STARTER MOTOR IMPORTANT FITTING NOTICE

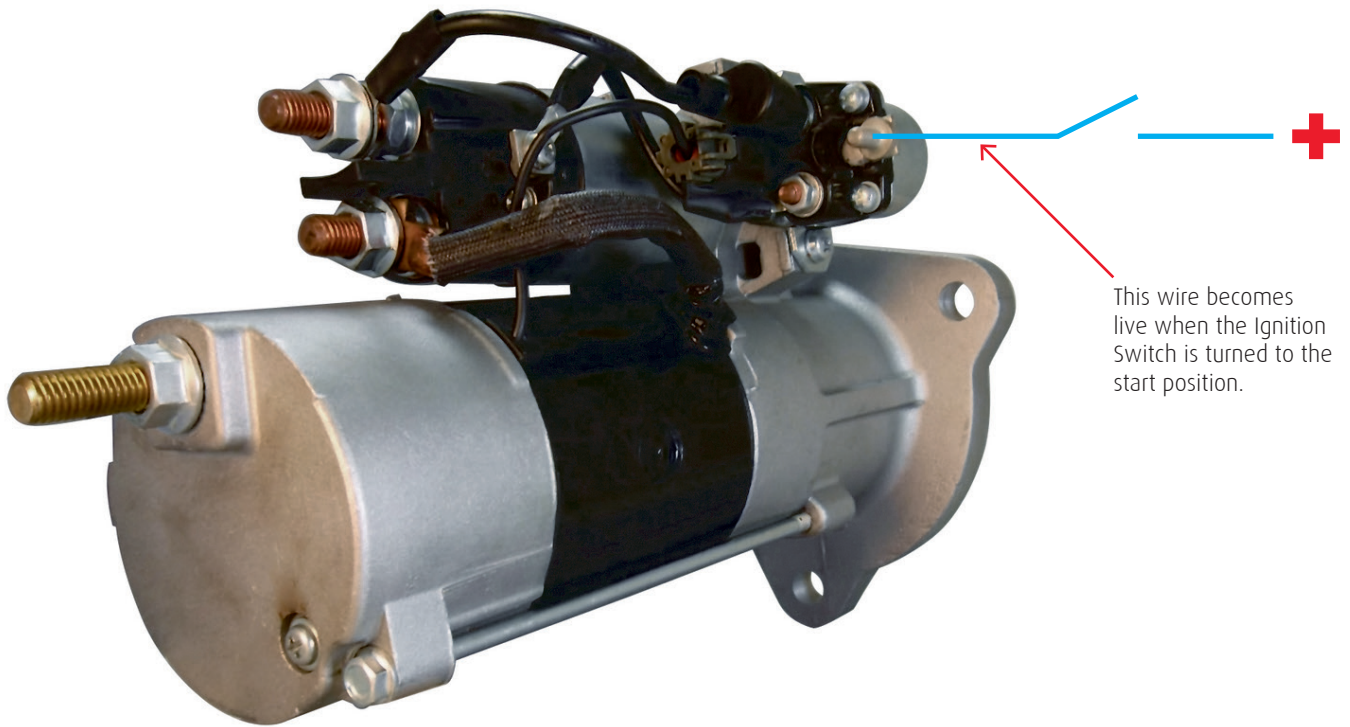
On some Renault applications, for example on the DXI engine, there are two wires that go to two terminals on the small solenoid of the starter motor.

When replacing with the ST1029 or ST10330EM, one of the two wires is discarded.

Only use the switched wire from the ignition switch to energise the small solenoid as shown in the illustration above.
